MOUND PLANT Potential Release Site Package PRS # 86

**MOUND PLANT
PRS 86
ACTINIUM CONTAMINATION
NEAR UNDERGROUND SEPTIC TANK**

US DOE MOUND PLANT
Operable Unit 5
Action Memorandum/Removal Site Evaluation
Area 7 Removal Action
Draft (Revision 1)
Ohio EPA Comments
September 1995

US DOE MOUND PLANT
Operable Unit 5
Action Memorandum/Removal Site Evaluation
Area 7 Removal Action
Draft (Revision 1)
USEPA Comments
September 1995

Figure 2.4. Conceptual Model

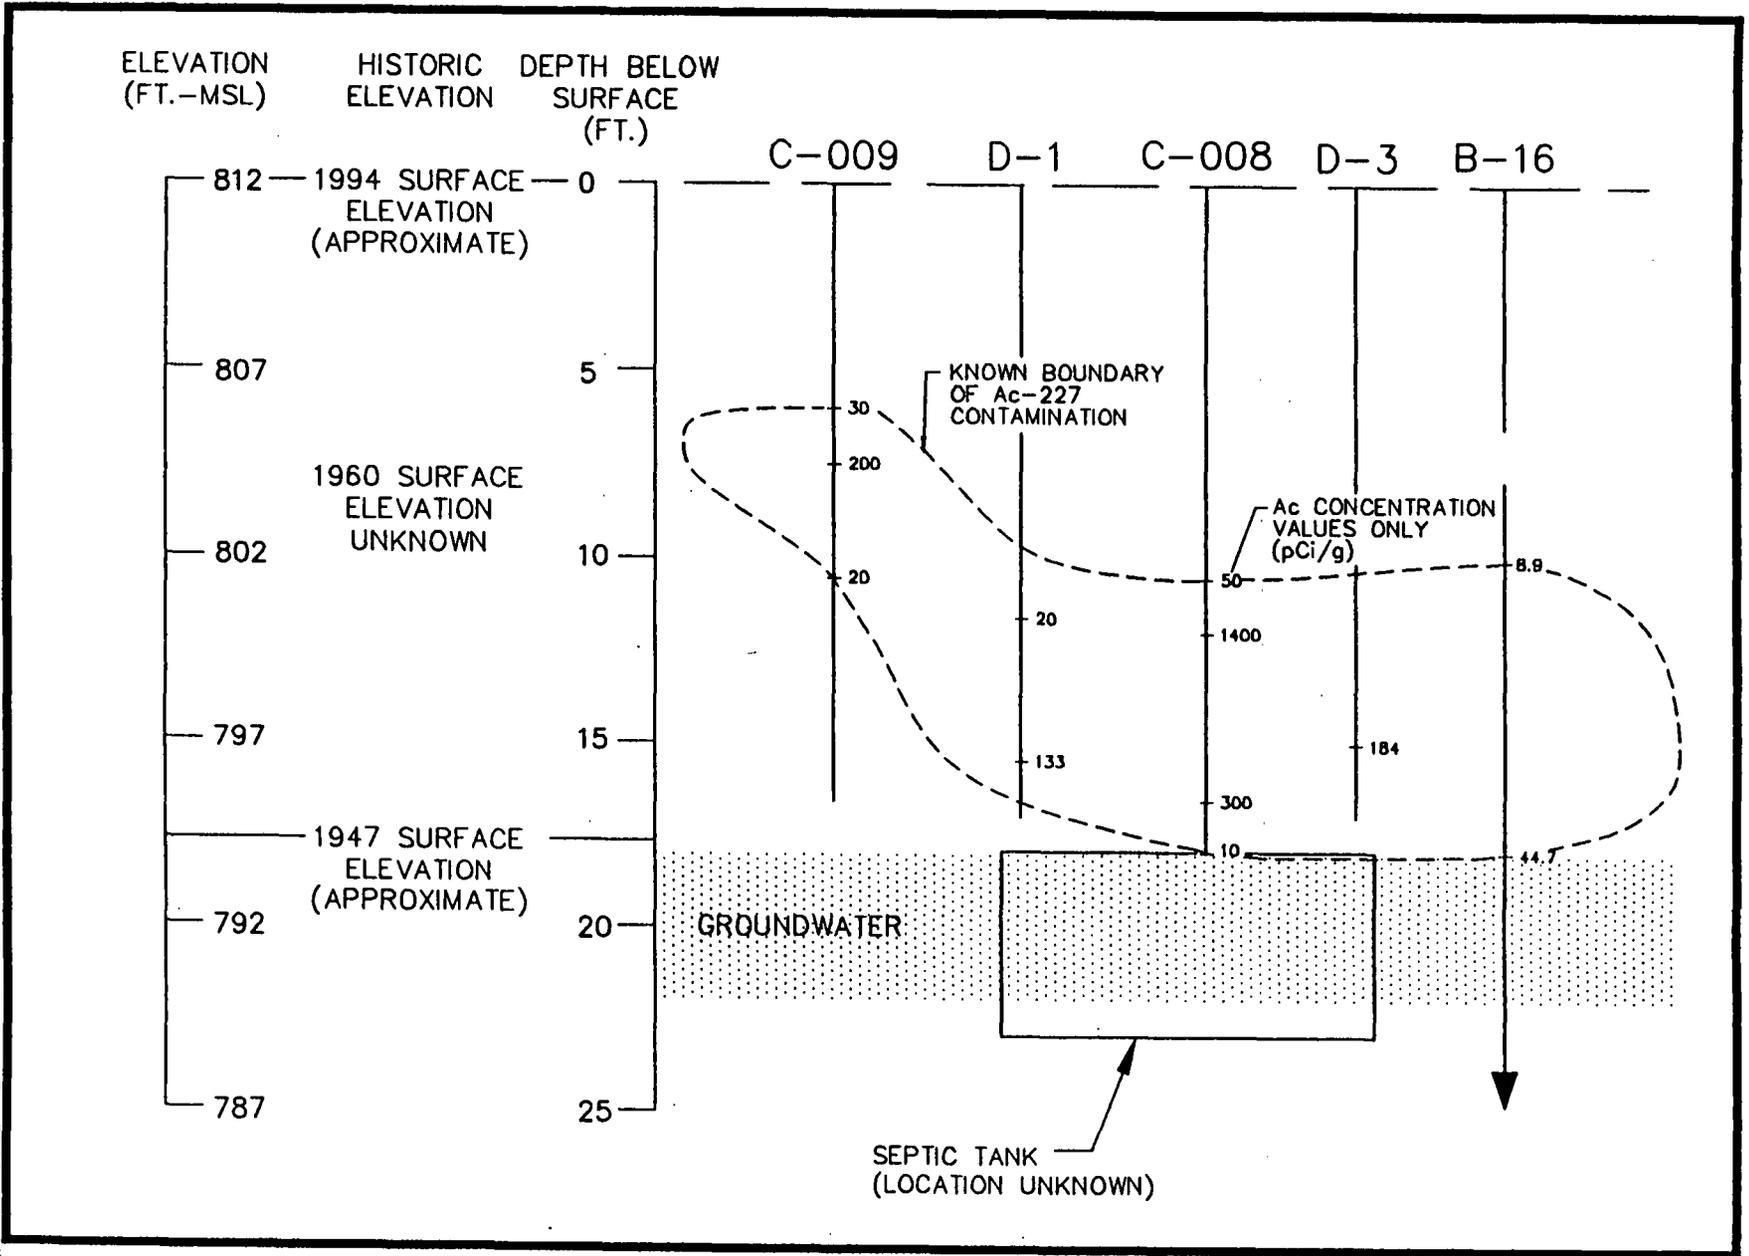
Comment #2: Section 2.1.4 Release or Threatened Release into the Environment
Page 2-11, Figure 2.4

Designators should be included on the figure to indicate the cross-section orientation (east-west or north-south).

Comment #3: Section 5.1 Proposed Action
Page 5-1, Paragraph 1

A 20 ft. by 20 ft. excavation area does not cover the entire area shown by the Conceptual Model, Figure 2.4, and does not remove all soil greater than 5 pCi/g, the interim clean-up goal for actinium-227 mentioned on page 3-1. Please show on a figure the 20 ft. by 20 ft. area that is being targeted for excavation.

Response #2: Figure 2.4 is conceptual representation of the subsurface contamination and is not scaled in the horizontal direction. However, by referring to Figure 2.2, the conceptual model is approximately a east-west cross-section viewed looking north.

Response #3: The objective of the removal action is not to remove all actinium-contaminated soil in Area 7 that is above a concentration of 5 pCi/g. Rather, the objective is to mitigate source migration by excavating a specified volume of soil from a predetermined excavation configuration, as described in Section 5.1.1. Using known soil sampling and

historical information, the excavation will be centered over the area of the suspected source of contamination. The 20 ft. by 20 ft. excavation will be centered in the 50 ft. by 50 ft. area (identified as the approximate location of removal action) shown in Figure 2.2.
